Subject: ***Letter of Intent***  
***Temporary Don Miller Dodge Central Parking Lot Expansion***  
***854 E. Washington Avenue***  
***Madison, Wisconsin 53703***  
***JSD Project No. 07-2859***

Re: **Don Miller – 854 E Washington Avenue**

The proposed Don Miller Central Dodge temporary parking facility at 854 E. Washington Avenue, which is at the corner of East Washington Avenue and North Paterson Street has been revised per UDC comments. Below, please find the revisions requested at the August 8, 2007 UDC meeting and the associated revisions made or justification of no revision. Please refer to Exhibit A for the Site Locator Map and Existing Conditions Survey, Exhibit B for the Site Plan and Erosion Control & Grading Plan, and Exhibit C for the Landscape Plan.

SHEET TITLE  
**SITE PLAN**

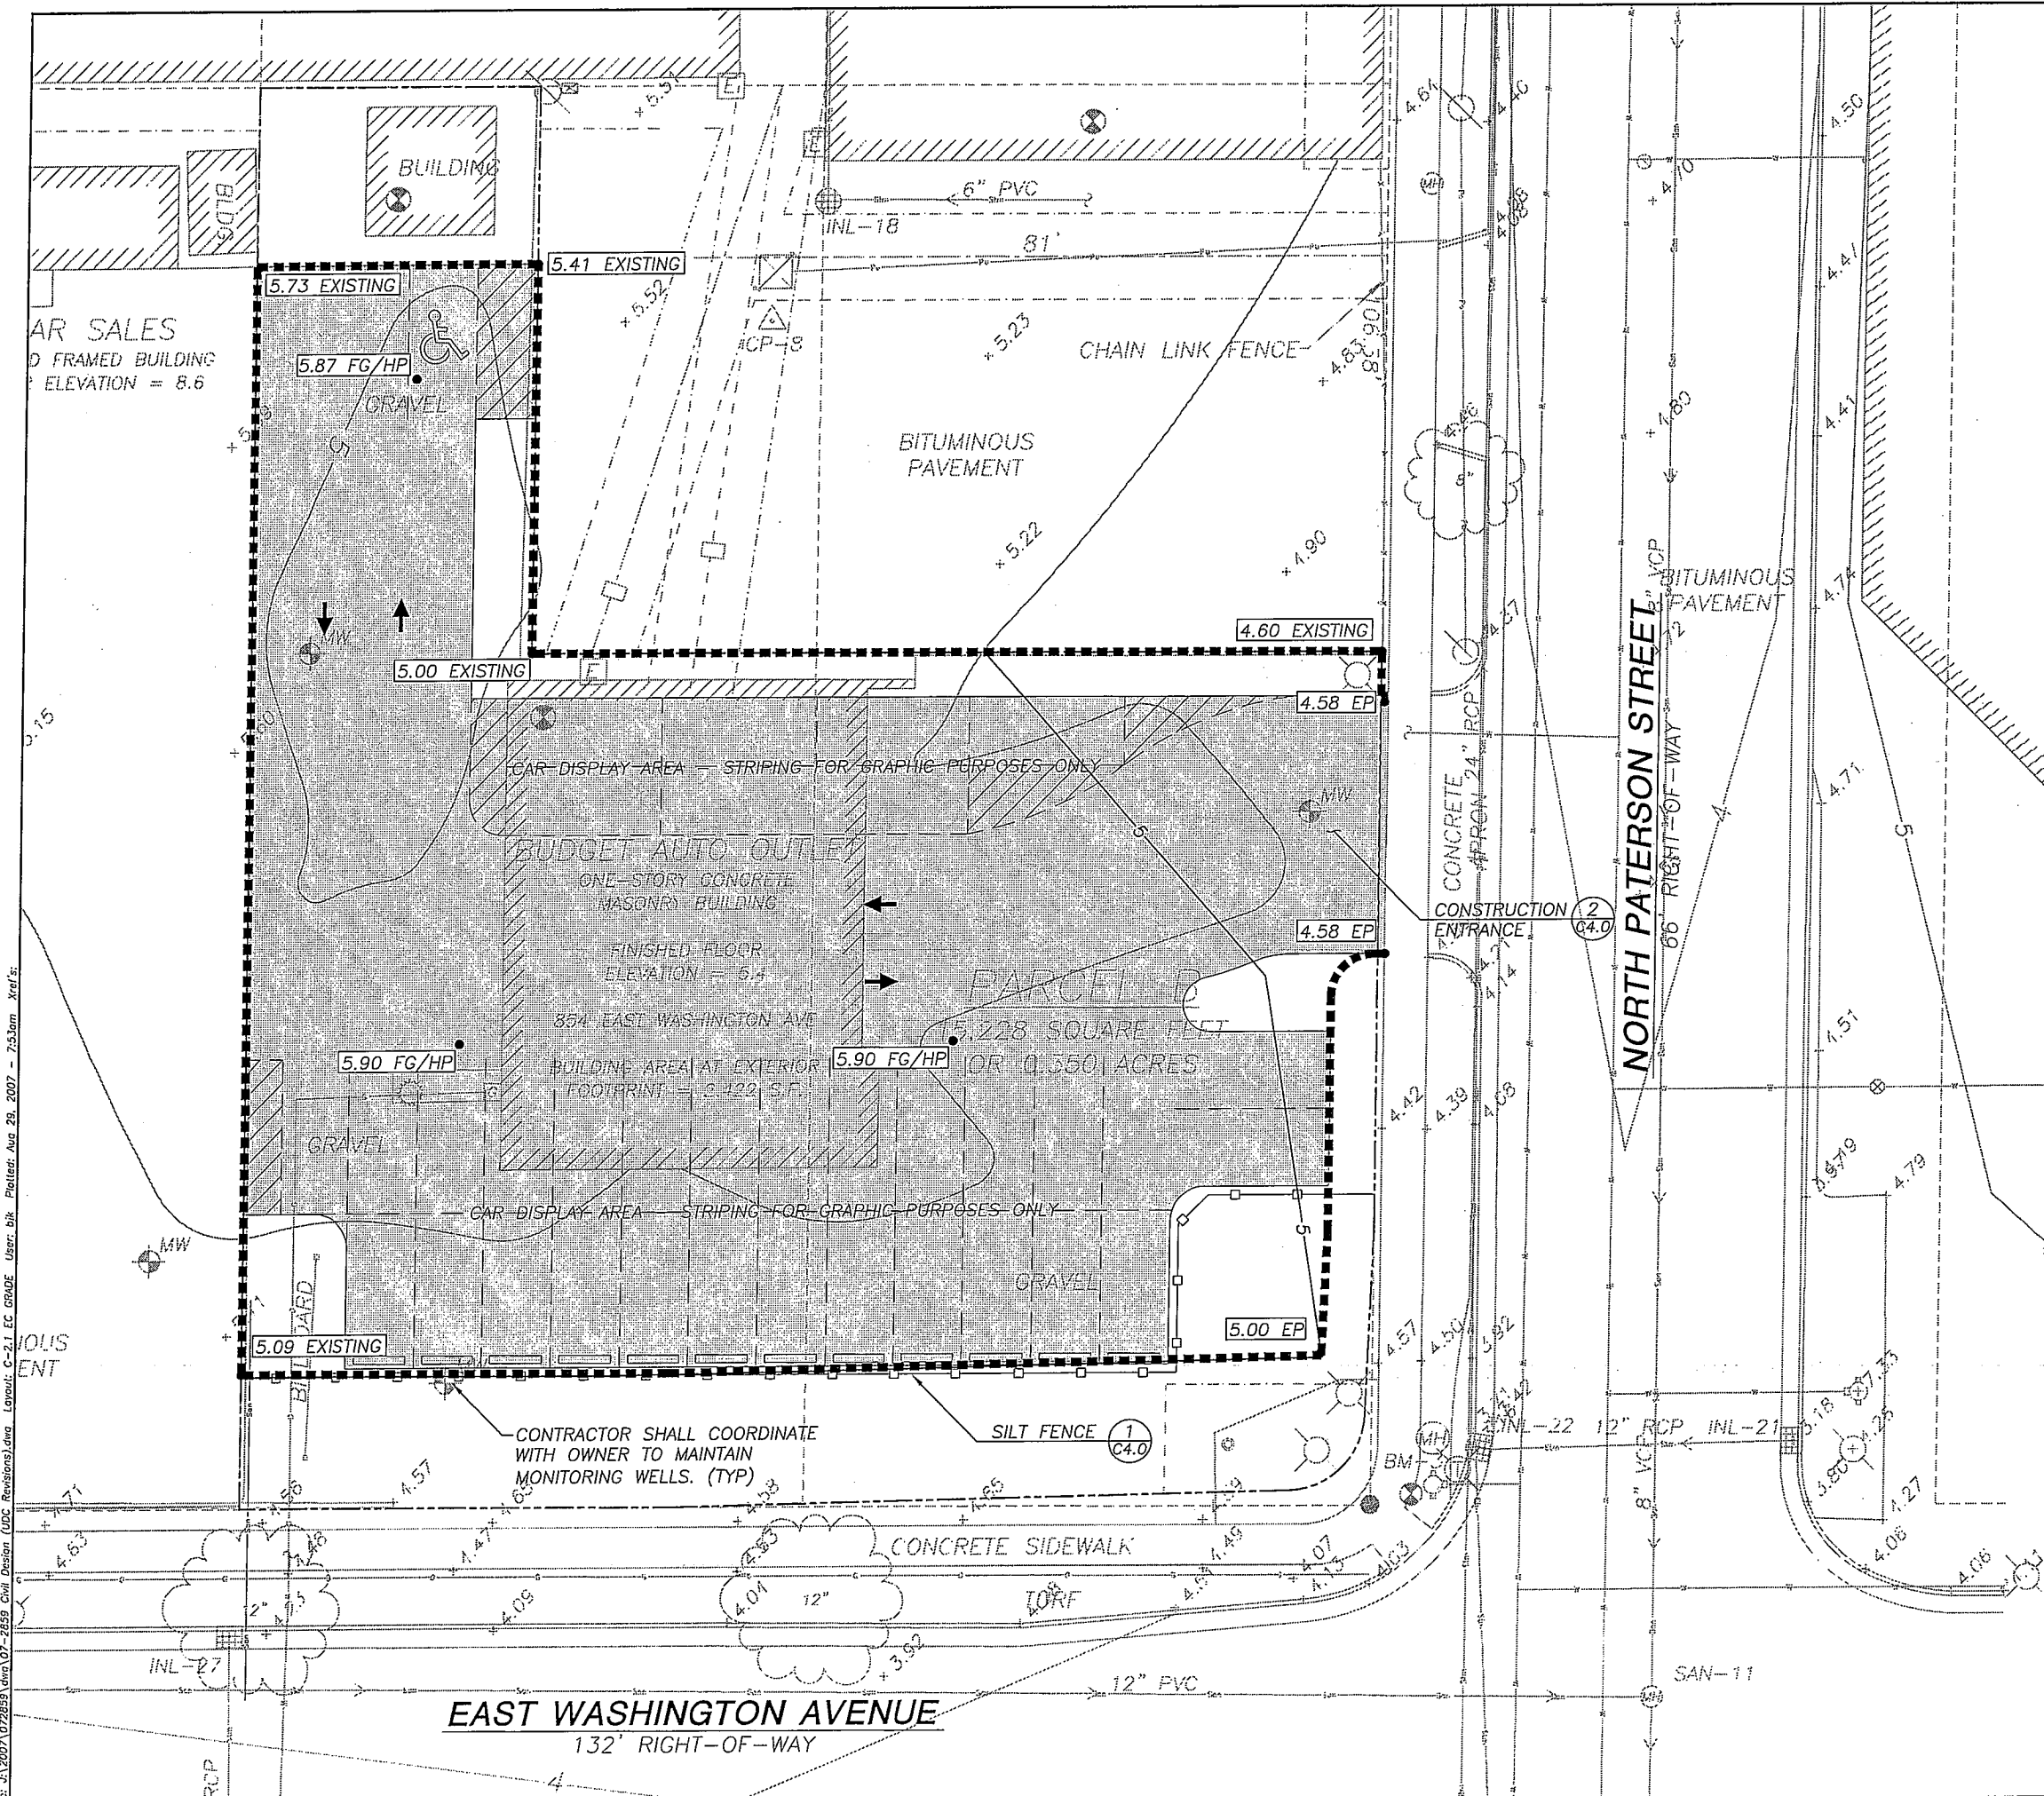
1. A proposed paved area located in the apex of the corner of the site should be cut out and be utilized to provide for more landscaped green area due to its unusability for parking and display purposes.

2. Consider angle parking with a 1-way directional traffic drive-aisle loop, create more greenspace in lieu of the proposed development of display area featuring a 2-way drive-aisle system.

6. Consider redesigning to create a double-loaded parking to provide for more green space along the westerly property line.

7. Redesign to incorporate more tree islands at minimum interval of 12 to 15 stalls.

*The paved area in the apex of the corner of the site has been removed and has been replaced with landscaped green area. Please refer to sheet C-2.0 for the Site Plan and Sheet C-3.0 for the Landscape Plan detailing plant selection and planting pattern for this area.*

*The parking area has been revised in coordination with John Leach, City of Madison Traffic Engineering. There is a 26' fire access lane running through the parking lot and all stalls have been drawn in for graphic purposes only. There will be no striping of the parking lot, as it will serve as additional display area for Don Miller Dodge Central. Display area has been loaded along East Washington Avenue in an effort to create more greenspace in the northwesterly portion of the site.*

*Please refer to revision note no. 2. Loading the parking along East Washington Avenue has created enough room along the northwesterly portion of the site to install a 5' greenspace buffer. This buffer has been designed with plantings that will significantly increase the number of landscape points on the site. Please refer to Sheet C-2.0 for the Site Plan that illustrates the greenspace area and Sheet C-3.0 for the Landscape Plan detailing plant selection and planting pattern in this area.*

*The display area has been significantly altered and will no longer have drive aisles through the middle of the parking lot. A small tree island has been added along the entrance into the display lot and the area under the billboard will no longer be paved. Instead, the area under the billboard has been converted to greenspace and has been landscaped with trees and shrubs, neither of which will encroach on the billboard visibility. Please refer to Sheet C-2.0 for the Site Plan illustrating the additional greenspace and Sheet C-3.0 for the Landscape Plan detailing plant selection and planting pattern in this area.*

SHEET TITLE  
**LANDSCAPE PLAN**

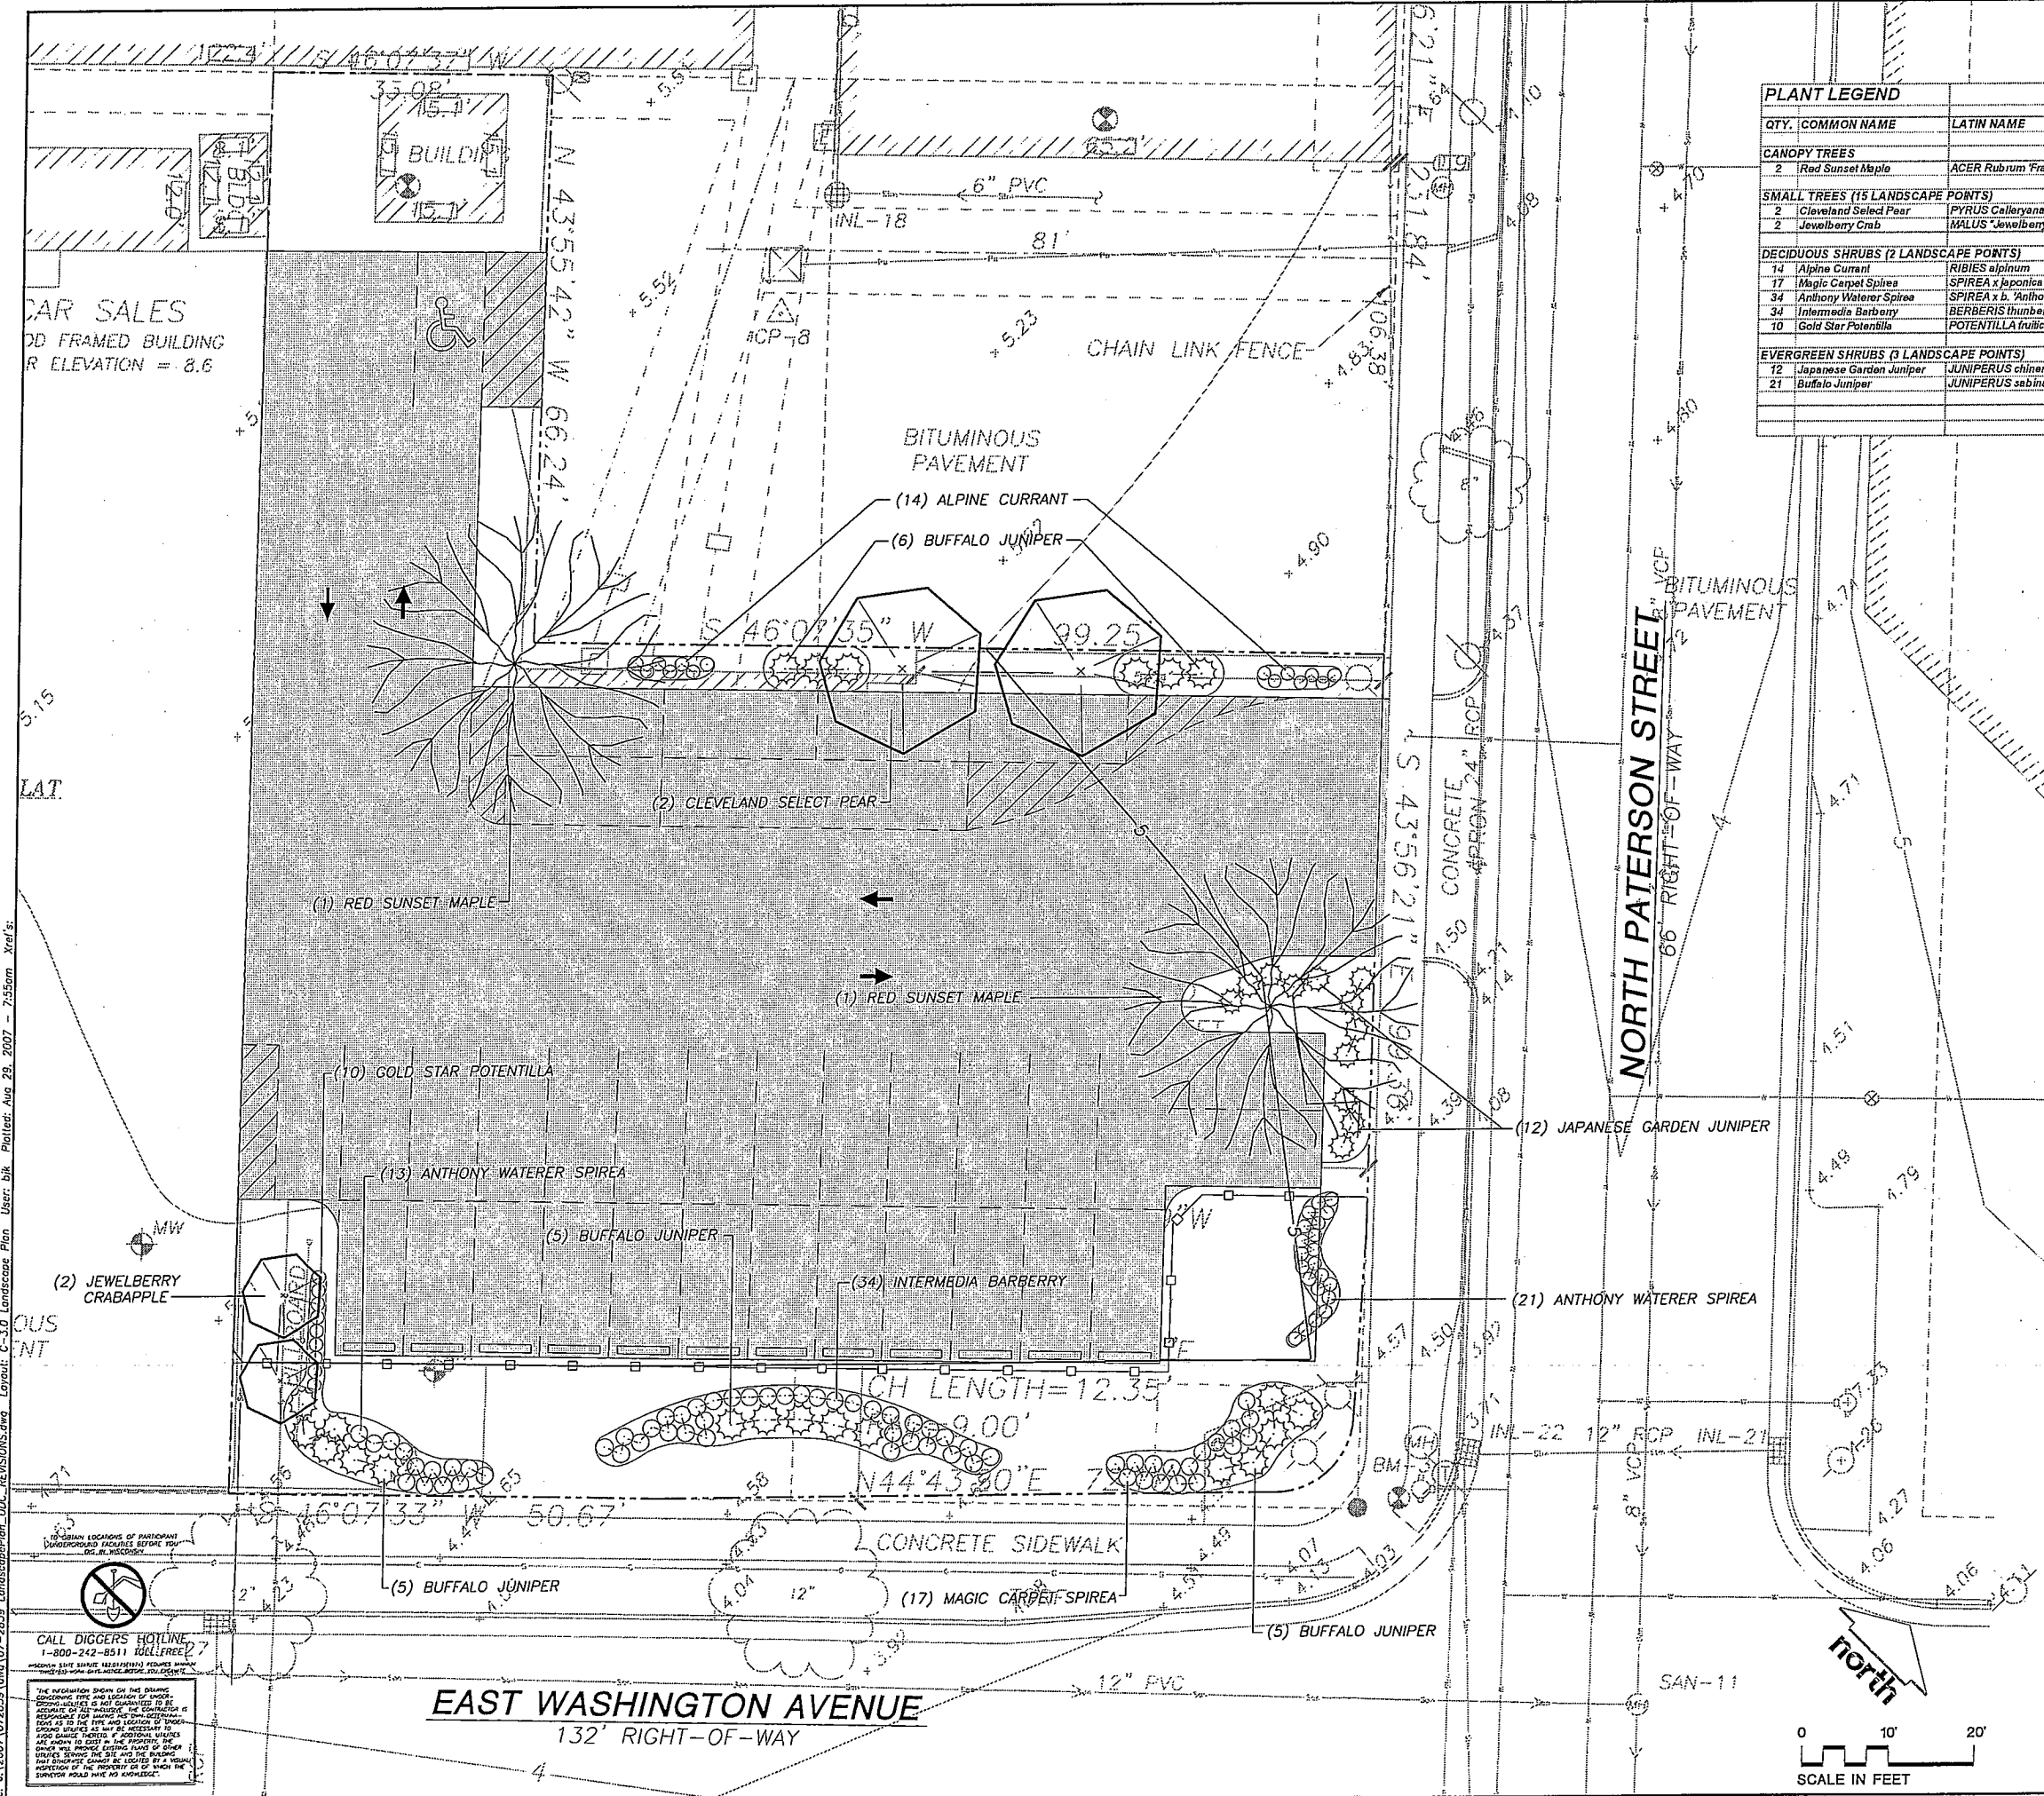
3. Add a 2-1/2 foot tall hedge along East Washington Avenue since it is not a show lot for display cars with parking for employees. \*Noted as for display of cars in application.

4. Do something with the corner to complement corner treatment of the adjacent Breese Stevens Field.

8. Revise the landscape plan to address the Urban Design Commission's usual standard of 2 to 3 times the number of required landscape points.

*This is in fact a display lot for Don Miller Dodge Central. Therefore, the hedge has been kept at approximately 2 feet in height. A curvilinear planting diagram has been established along East Washington Avenue in response to UDC requests. The relative planting density has also been increased in an effort for improved site aesthetics. Please refer to Sheet C-3.0 for the Landscape Plan detailing plant selection and planting pattern in this area.*

*Please refer to revision note no. 1. The Landscaping Plan has been created to provide an unobstructed line of sight around the intersection and towards Breese Stevens Field. Please refer to Sheet C-3.0 for the Landscape Plan detailing plant selection and planting pattern in this area.*

*The landscape plan has been revised and the number of landscape points has been increased substantially from the amount required. Please refer to Sheet C-3.0 for the Landscape Plan that includes a landscape points table and details the planting selection for the site.*
